DEVELOPMENT APPLICATION ASSESSMENT REPORT

Application Number:	DA2024/1623
Responsible Officer:	Dean Pattalis
Land to be developed (Address):	Lot 31 DP 33000, 84 Hilma Street COLLAROY PLATEAU NSW 2097
Proposed Development:	Demolition works and construction of a dwelling house including swimming pool
Zoning:	Warringah LEP2011 - Land zoned R2 Low Density Residential
Development Permissible:	Yes
Existing Use Rights:	No
Consent Authority:	Northern Beaches Council
Land and Environment Court Action:	No
Applicant:	Hendrik Jan Fredrik Menke
Application Lodged:	02/12/2024
Integrated Development:	No
Designated Development:	No
State Reporting Category:	Residential - Single new detached dwelling
Notified:	13/12/2024 to 20/01/2025
Advertised:	Not Advertised
Submissions Received:	2
Clause 4.6 Variation:	4.3 Height of buildings: 4.59%
Recommendation:	Approval
Estimated Cost of Works:	\$ 1,171,500.00

The development application seeks consent for the demolition of an existing dwelling and construction of a new two storey dwelling, driveway, swimming pool and front fence.

Figure 1: Ridge above existing excavated ground level and extrapolated natural ground level

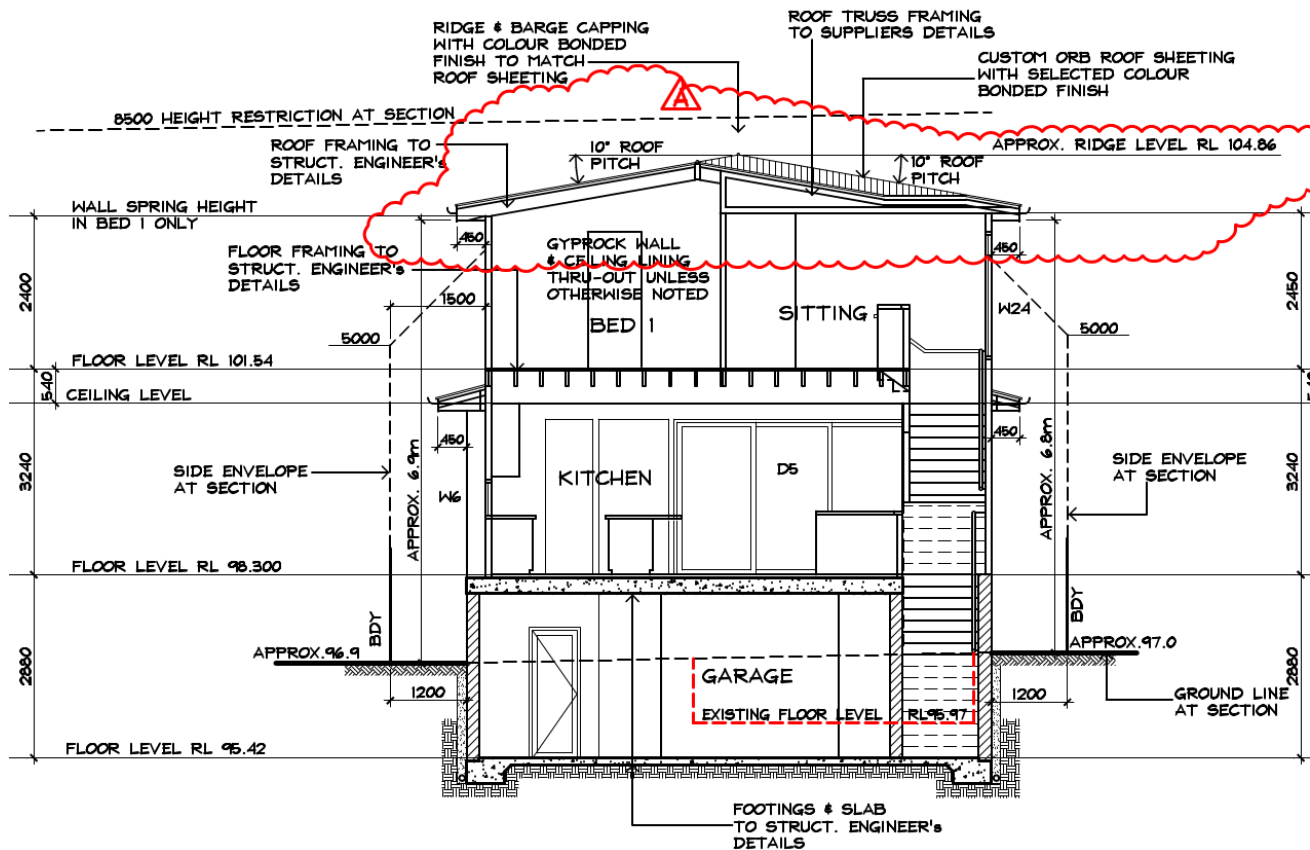
- The site is located on substantially sloping topography which falls towards the front boundary the site.
- The proposal features generally minimal floor to ceiling heights with a low pitched roof.
- The non-compliance is a result of the existing excavated floor level at the lower ground floor garage. The proposed height is generally compliant above the natural extrapolated ground level of the site.

It is agreed that whole compliance with the control is constrained by the existing site conditions outlined by the applicant. The site is located on a sloping topography whilst also having an existing excavated lower ground floor which directly results in the non-compliance. Notwithstanding, the proposed height is considered to retain numerical compliance above the natural extrapolated ground level of the site. Furthermore, the proposed first floor is considered to be appropriately minimised with a low floor to ceiling height and flat pitched roof. The proposal is also not considered to be inconsistent with the general height and scale of surrounding developments within the streetscape.

Figure 2: Black hatched area showing envelope encroachment

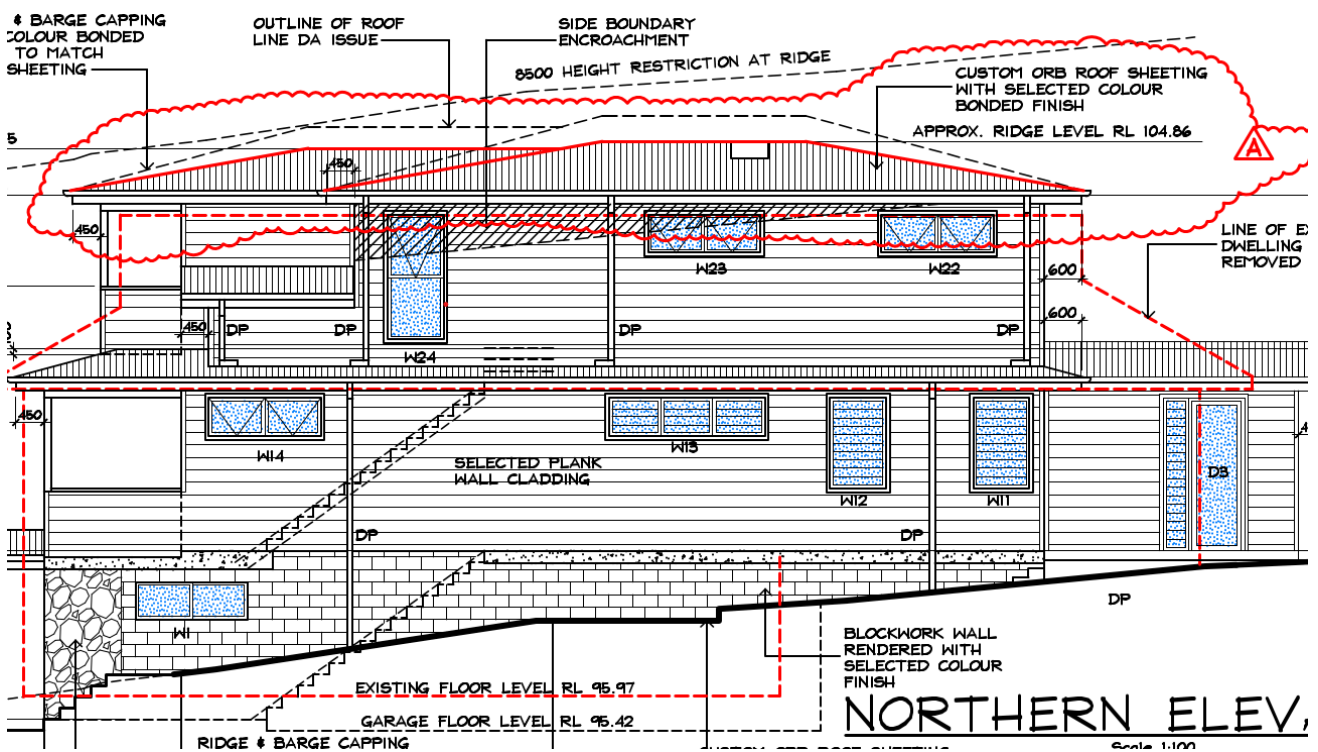
The proposed first floor encroaches the building envelope by a maximum of 0.8m on both the north and south side elevations.

Figure 3: Black hatched area showing area encroachment

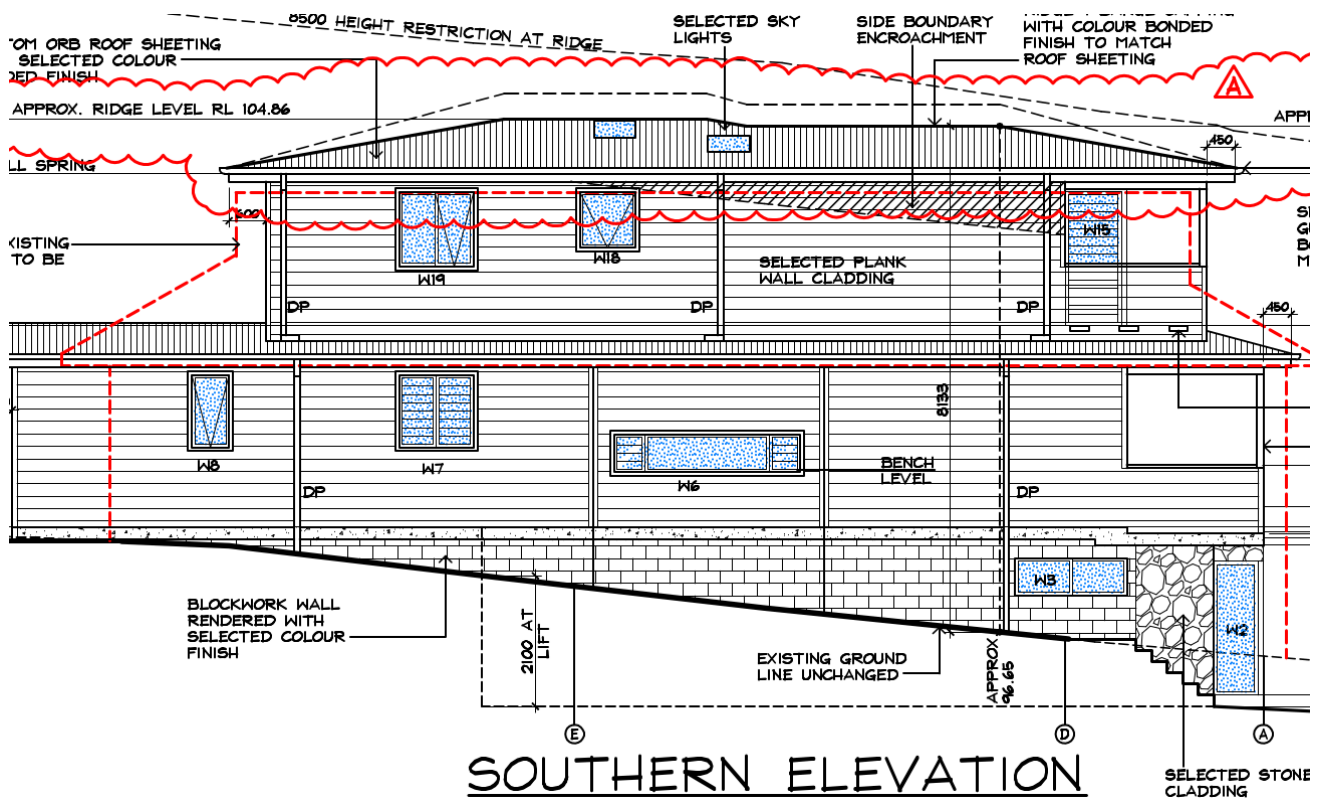
The proposed development is adequately setback from the side boundaries whilst the horizontal length of the proposed area of non-compliance is generally minor. Therefore, the proposed variation is considered to be a result of existing site constraints including the moderately sloping topography.
